Town of Hilton Head Island  
**Design Review Board Meeting**  
**Tuesday, July 27, 2021 – 1:15 p.m.**  
Benjamin M. Racusin Council Chambers

i. The Charles, DRB-001668-2021

i. St. Andrew By-The-Sea United Methodist Church Pope Avenue Entry, DRB-001654-2021

i. 15 Wimbledon Court, DRB-001665-2021

**THE CHARLES**  
 LANDSCAPE PLAN

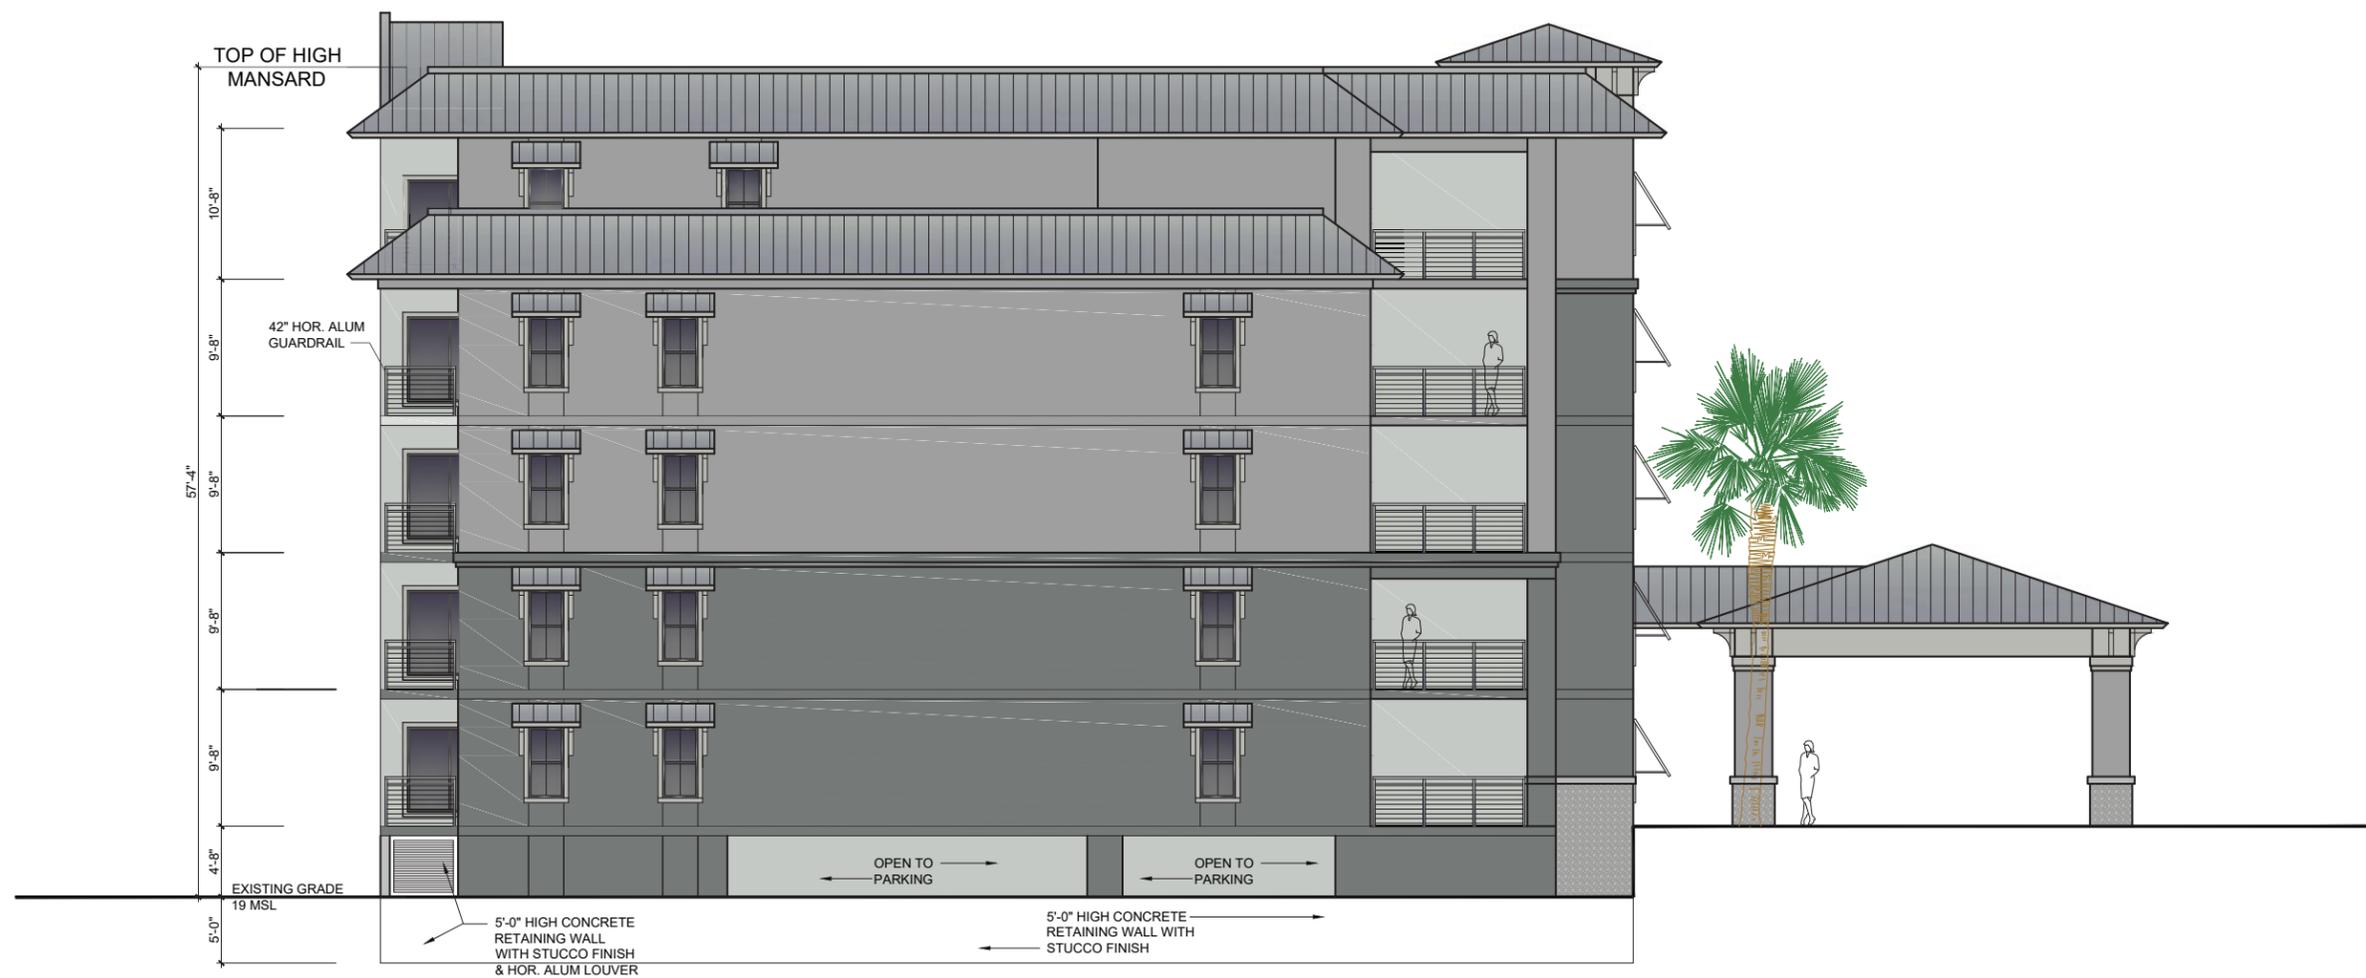
DESIGN GUIDE/LMO CRITERIA	Complies Yes	No	Not Applicable	Comments or Conditions
Provides Landscaping of a scope and size that is in proportion to the scale of the development	<input type="checkbox"/>	<input checked="" type="checkbox"/>	<input type="checkbox"/>	The landscape plan is only conceptual in nature.
